WINE EDUCATION CENTER  
NAPA VALLEY COLLEGE  
- PHASE 2  
(HOSPITALITY BUILDING)

ADDENDUM NUMBER 6

DATE  
**MARCH 27, 2025**

DSA APPLICATION NUMBER:  
**01-120890**

**PHASE 2 - GFRC PATTERNS @ EXTERIOR WALLS**

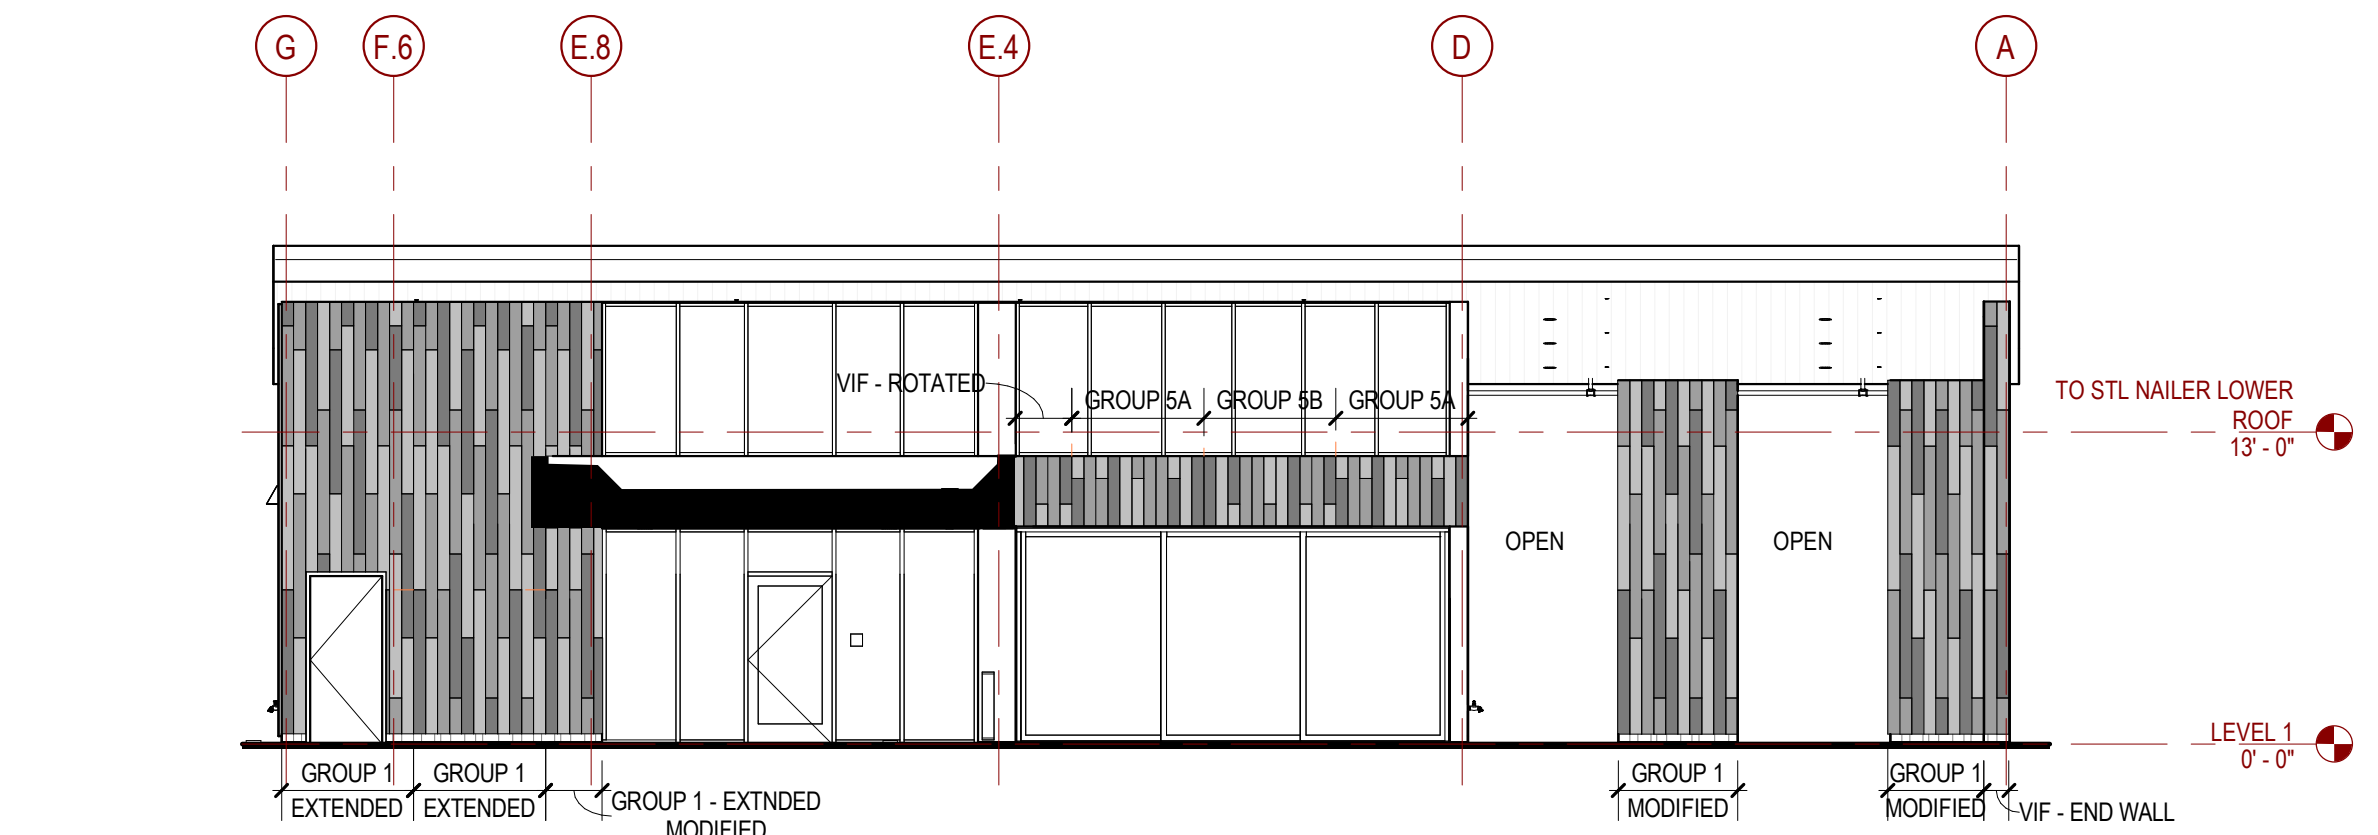
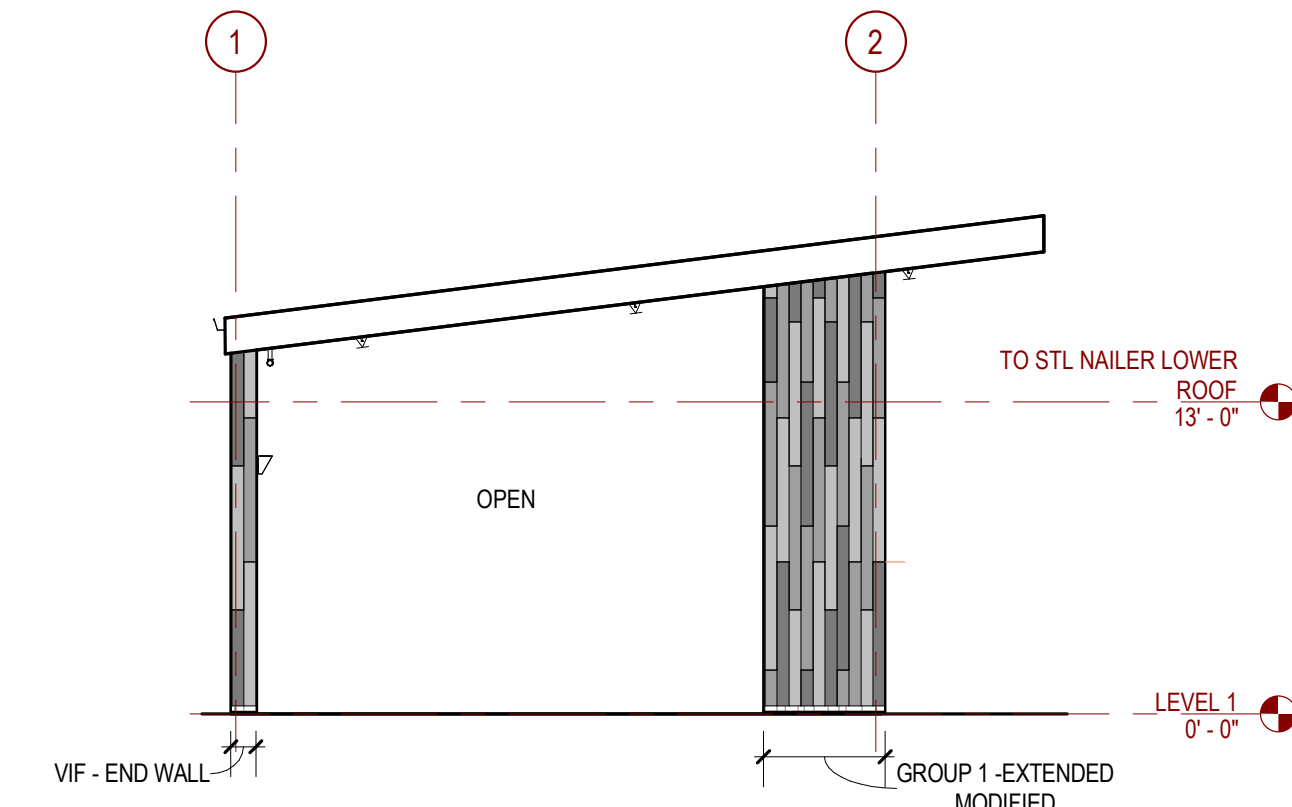
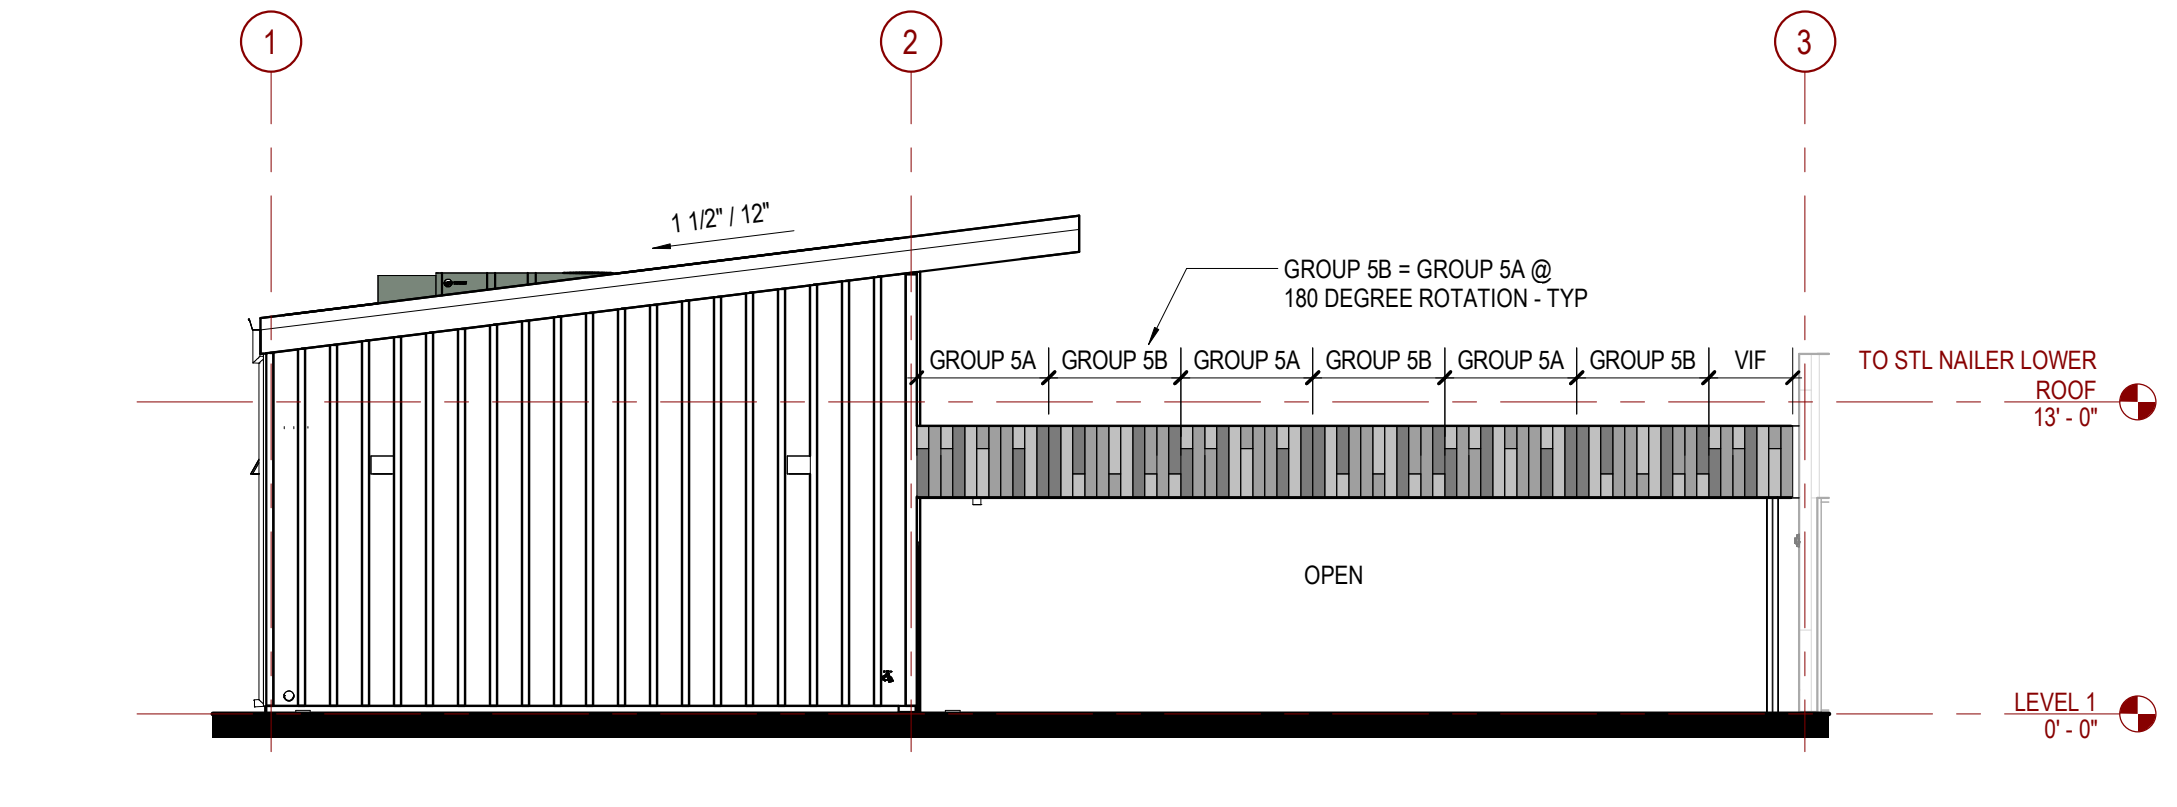
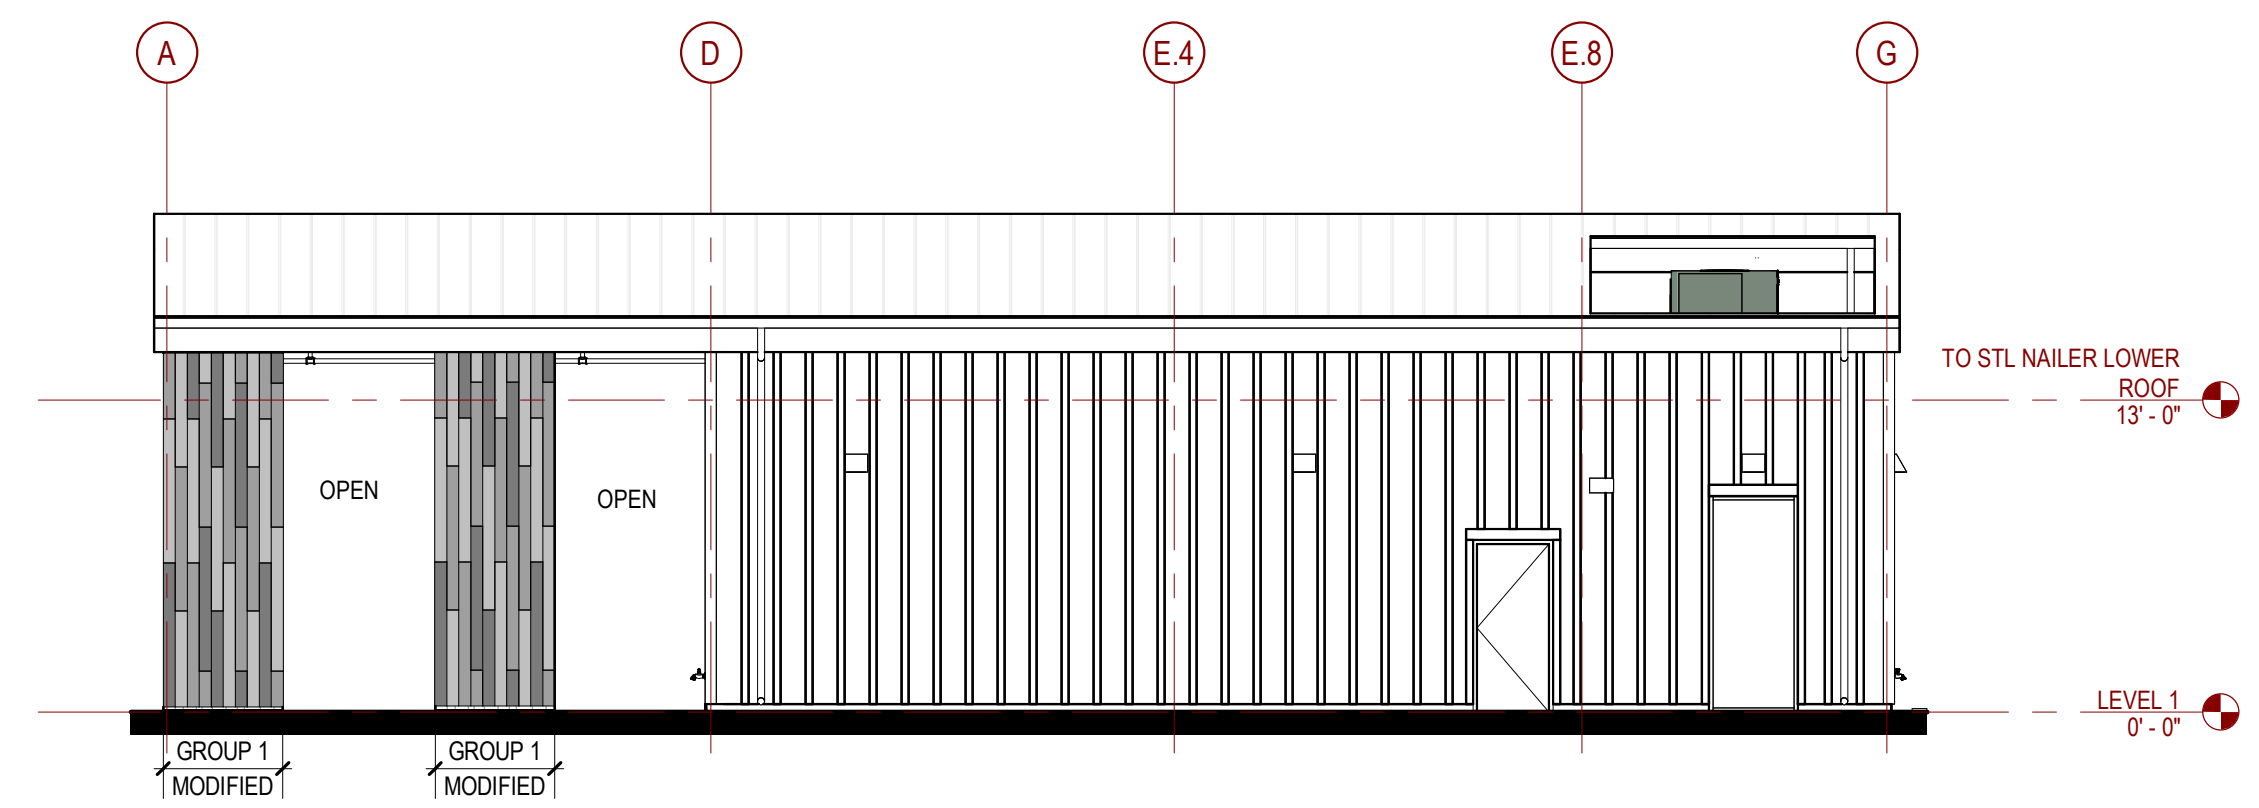
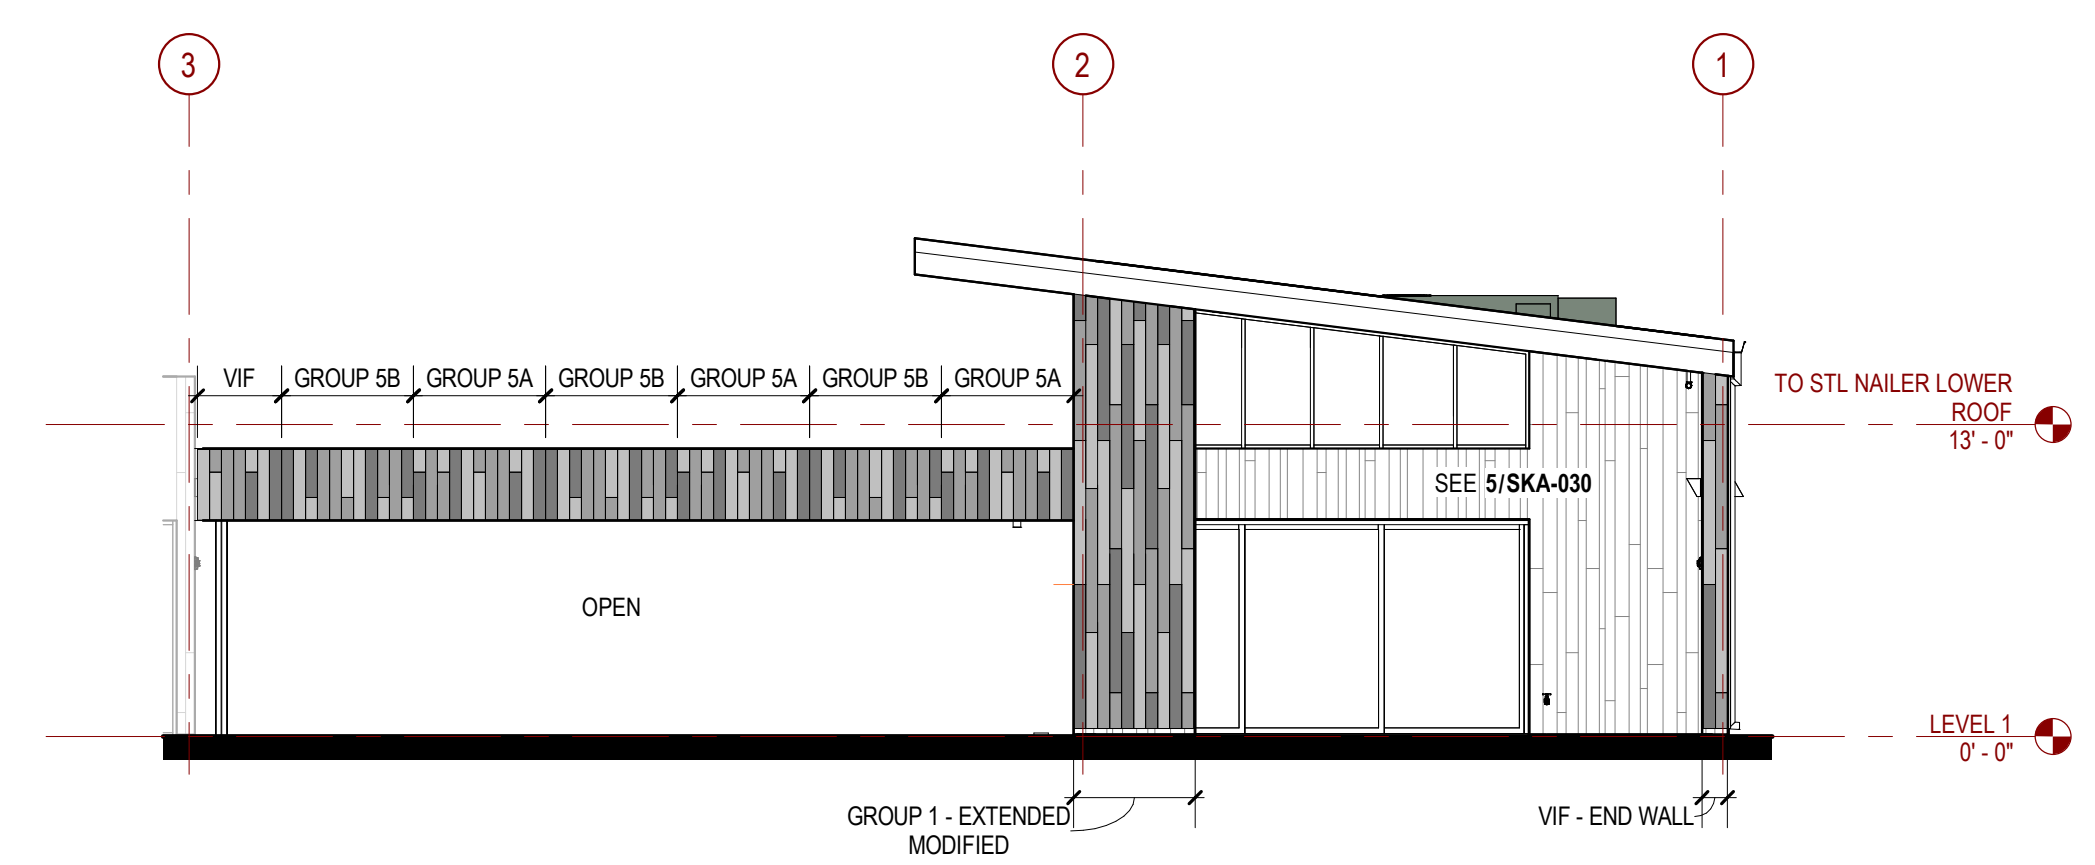
- d. West wall: Wall shall be fully sheathed due to double sided shear wall Type D.
- 1.3 **ADD** Drawing SKA-030 with clarifications to GFRC panel layout pattern.

- A. Refer to drawing SKA-030 for GFRC panel layout pattern for Phase 2. Refer to CCD 015, incorporated into the Phase 2 project in Addendum 4, for additional information for the exterior cladding system, attachments and waterproofing assembly. Refer to Addendum 5 for additional clarifications. Phase 2 GFRC products, attachments and assemblies shall match Phase 1 installation.
